ADDENDUM No. 4

REQUEST FOR QUOTATIONS No.: 1220-040-2024-087

TITLE: City of Surrey - Operations Building Tenant Improvement

ADDENDUM ISSUE DATE: November 19, 2024

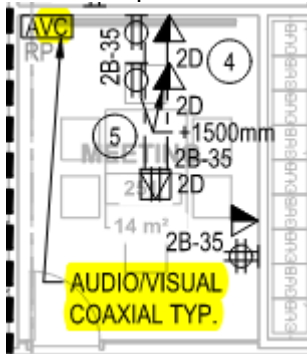
Q13. Please confirm if T-bar is to be attached directly to door frame heads as per 1/A0.02. Are the windows to be installed the same way?

A13. Refer to Architectural Addendum No. 2 issued November 19, 2024.
